RESPONSE TO SEPA COMMENTS (SEP2008-00128)
Proposed Floating Geoduck Seed Nursery System in
Case Inlet, Harstine Island, Mason County, Washington

The following is a response to comments on the state environmental policy act (SEPA) mitigated determination of nonsignificance (MDNS). The project is the Seattle Shellfish Floating Nursery project (SEP2008-00128) located in Spencer Cove (Case Inlet), Harstine Island, Mason County, Washington. The comments are provided by various sources. Each comment is identified by the commenter's name and/or their affiliation, and the date it was received. The response to each comment is provided directly below the text that was provided by the commenter.

Figure 2. Schematic of the sampling design used in Spencer Cove (Case Inlet) in association with the proposed floating nursery project. All proposed rafts are overlaid on the schematic and labeled in a north to south orientation.

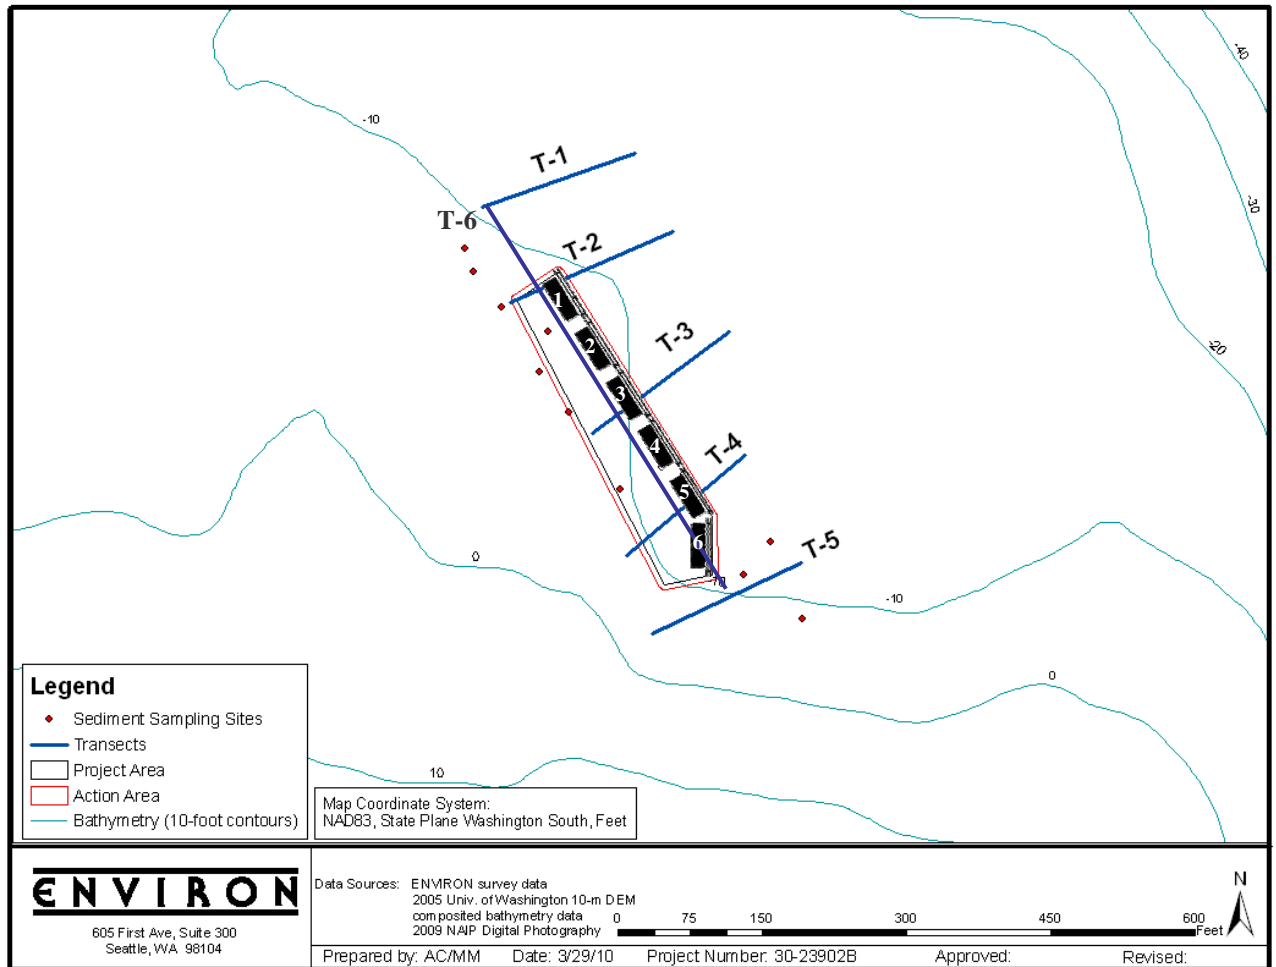
2. *Related to the above is an inconsistency in the depth these structures will be, leading to an incomplete description of their adverse impacts. On page 5 it is stated they are in 9 to 30 feet of water. On page 8 they are noted as being at a -7 ft MLLW to -13 MLLW, and referenced to a map with bathymetric lines as support. This significance is in how the subtidal habitat will be impacted. If the latter depth is accepted as being accurate then the structure underneath the rafts will come in direct contact with the sediments at any time there is a minus 1 or lower tide. More likely there will be contact before then as waves will also cause these structures to drop onto the sediments below them. Whether waves from storms or boating activity, this is a dynamic area.*

During the field survey performed on March 15, 2010, a comparison of existing bathymetry data (Finlayson 2005) and actual depths within the project area (in relation to MLLW) was made. Depths were measured from 17:46-18:26 during a tidal cycle ranging from 10.5 ft to 11.5 ft MLLW³. Depths corresponding to the inshore and offshore ends of five transects were measured in the field, referenced to 0 ft MLLW, and tracked with a Global Positioning System (GPS) unit (Figure 1, Table 1). Based on those measurements, it was noted that the depth range for the project area, in relation to MLLW, should be **-11 ft to -14 ft MLLW**. (Note that the transects extended farther than the project area, and so there is variation around this tidal range for the actual depth measurements).

Based on these measurements, an analysis of minimum depth under each raft was prepared (Table 2). The depth under each raft was calculated based on the transect depth measurements from Table 1, and the associated slope calculated from the inshore to the offshore depth measurement. (Note that all depth measurements were corrected for the tide height at the time of measurement and the actual vs. predicted tide height.) Three out of the six rafts coincided with transects measured in the field (i.e., Raft 1, Raft 3, and Raft 5). For all other rafts, the distance that coincided with the adjacent transect to the north was used for the position of the raft, and the slope was calculated based on the average of adjacent transects. Finally, the minimum depth of each raft was calculated by adding the depth change from the beginning of the transect to the location of each raft.

BE Figure 3. Profile view of the proposed floating nursery rafts in Spencer Cove (Harstine Island), Case Inlet, south Puget Sound, Washington.

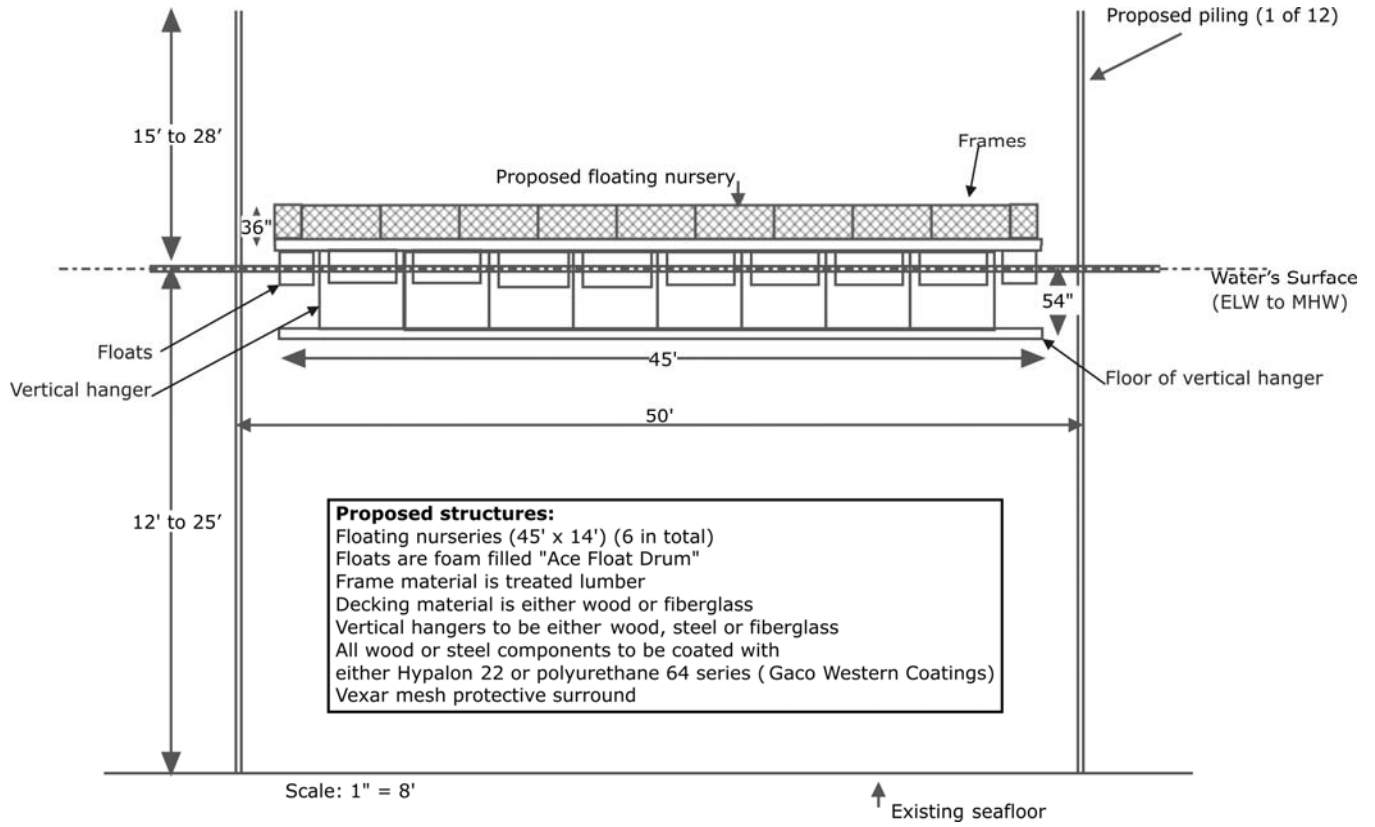
3. *The raft structures extend 70" (6') below waterline. These structures are a barrier which will re-direct tidal energies, both onto the shoreline as well as increase flow underneath the structures, scouring sand beneath them.*

4. *The structures are described as being at the -7 to -13 (MLLW) tidal level (p.8 ENVIRON). If there is a minus tide greater than -1 this will begin placing the structures onto the sediments of Spencer Cove, scouring the sediments (the 6' structure below the rafts). When elevated above the sediments the increase energy from accelerated tidal flow due to the blocking will also disrupt the sediments. Finally, wave action will also create hydraulic pressures beneath the structures preventing growth to take hold.*

- a. According to Seattle Shellfish, the 70-inch measurement associated with the rafts, as originally identified in figures in the JARPA and BE (corrected versions appended) was calculated from the top to the bottom of the raft. However, that included a portion of the raft that would be out of the water (16 inches or 1.3 ft). Therefore, the actual draft of each raft (with weight calculated in) would be the remaining 54 inches (4.5 ft).

- b. Based on field measurements, the tidal range has been modified from -7 ft to -13 ft MLLW to a range from -11 ft to -14 ft MLLW. These calculations have been corrected for the tidal height at which they were made and the predicted vs. actual tidal height experienced on the day of measuring.

- c. The entire project area was included in the tidal range evaluation; however, in terms of the position of the rafts, they would occur at the very seaward edge of the project area next to the log boom. Additionally, the rafts only extend out a distance of 14 feet (see corrected project drawings below). Because there is a dog-leg in the project area (Figure 1), and the log boom extends farther out than the rafts, the total tidal range for the project extends beyond the rafts. According to the revised tidal range of the project area (-11 to -14 ft MLLW), the first raft would occur at a depth of -12 ft MLLW (Table 2). In other words, there is a full foot of depth between the start of the project area and the first raft.

BE Figure 4. Plan view (A) and individual tray group (B) perspective of the proposed floating nursery rafts and plastic trays in Spencer Cove (Harstine Island), Case Inlet, south Puget Sound, Washington.

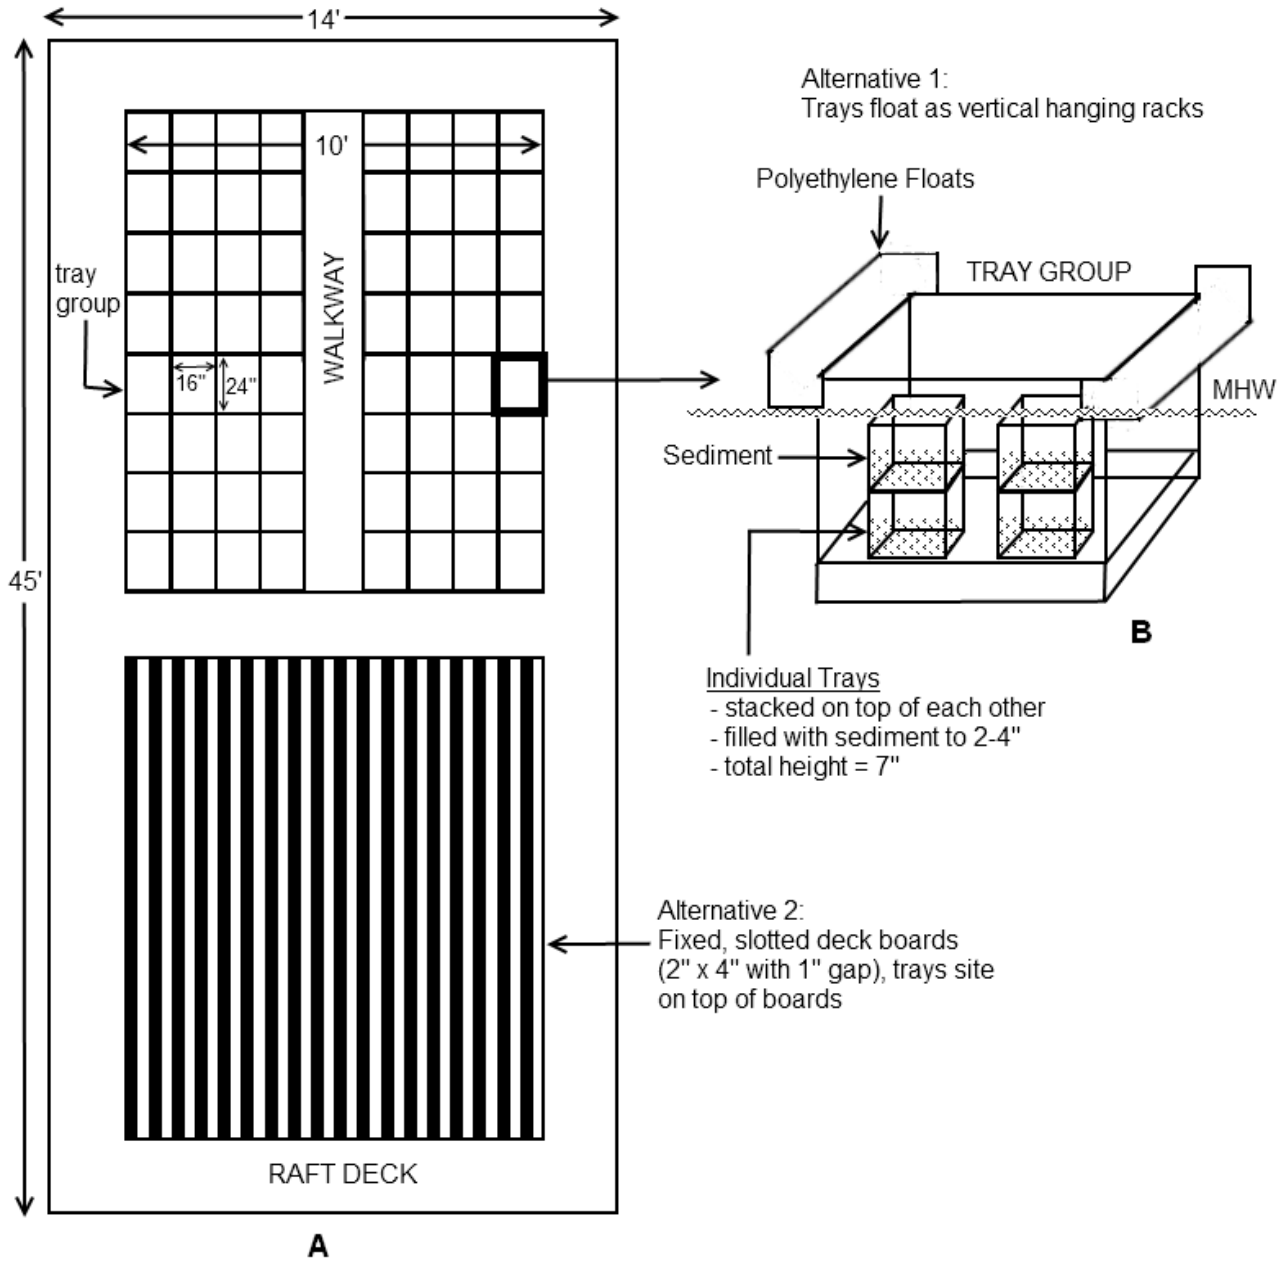
1. *In discussion about the impact from this project virtually all is focused on the effects from the pilings, log booms, and rafts. What is not found is the additional impact from the 6' (70") platforms extending below each of the rafts which hold what appear on page 7 to be multiple layers of plastic seed trays. As each raft holds 64 trays per layer, and there appears to be multiple layers, it is not an insignificant structure. Whether the resulting shade created; re-direction of current around the structure; or acceleration of current underneath the structure, its impact on the subtidal habitat needs to be considered. According to WDFW maps published last year there are priority habitats immediately adjacent to this project (e.g., saltwater wetlands) and potential surf smelt/sand lance spawning areas which would be impacted by a change in current or wave direction from this project.*
